GROUP 16 ENGINE ELECTRICAL

IGNITION SYSTEM

OUTLINE OF CHANGE

CRANK ANGLE SENSOR <4G9>

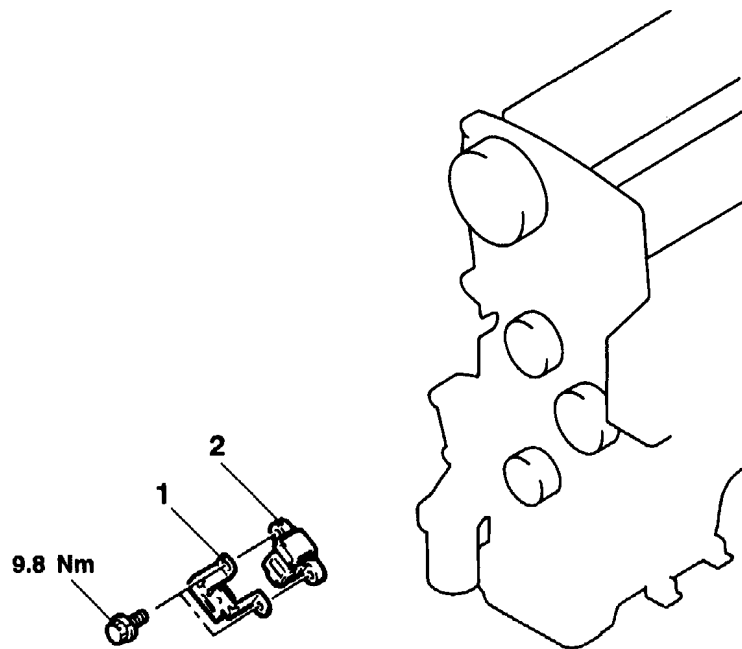
The crank angle sensor for the 4G9 engine has been changed.
